SUBJECT: Final Rule: Safety Standard for Portable Bed Rails

Staff Briefing Package: Draft Final Rule for Portable Bed Rails, from Rohit Khanna, dated February 2012.

16 CFR Part 1224

Safety Standard for Portable Bed Rails: Final Rule

Figure 8: Determining misassembly/functional bed rail test setup

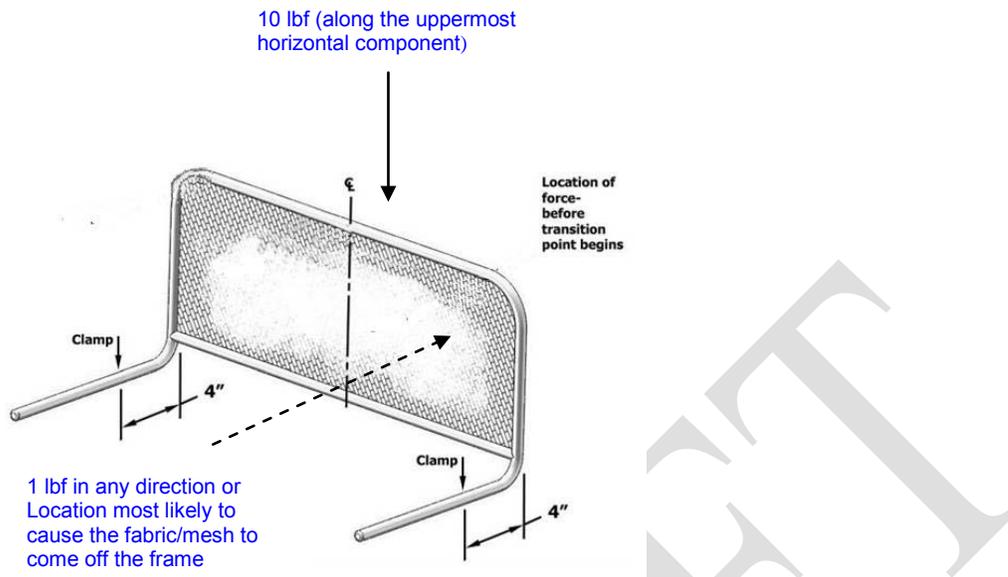
- *8.7 Test Method for Determining Acceptability of Vertical Structure of a Misassembled/Functional Portable Bed Rail:*
- 8.7.1 If possible, attempt to assemble the bed rail in a misassembled configuration(s), as defined in 6.9 *Determining Misassembled/Functional Portable Bed Rail:*
- 8.7.2 Firmly secure the misassembled portable bed rail on a table top or other stationary flat surface, using clamps. The clamps should be located 4 to 6 inches from the intersection of the portable bed rail legs to the vertical plane (see figure 8).

- 8.7.3 Gradually apply a force of 10 lbs, using a ½-inch disc to the uppermost horizontal component of the rail in a downward direction at a location along the horizontal component that would most likely vertically deform the bed rail (see figure 8). Apply the force over a period of 5 seconds; hold the force for 10 seconds, and release.

Section 6 in ASTM F2085-12 establishes requirements for determining misassembled portable bed rails, by targeting specific misassembled portable bed rail scenarios, such as missing horizontal components, fastening the fabric mesh without engaging a horizontal bar, and assembling parts to the wrong components or inverted components. ASTM F2085-12 does not have a test to determine acceptability of the vertical structure of a misassembled/functional portable bed rail. The testing laboratories are in the best position to determine whether a misassembled bed rail appears to be functional (failing the standard) or appears not to be functional (passing the standard). Accordingly, we believe that the new requirements under sections 5 (General Requirements) and 6 (Performance Requirements) are an improvement over the proposed rule's test requirements; accordingly, our proposed requirements in section 8 are not necessary.
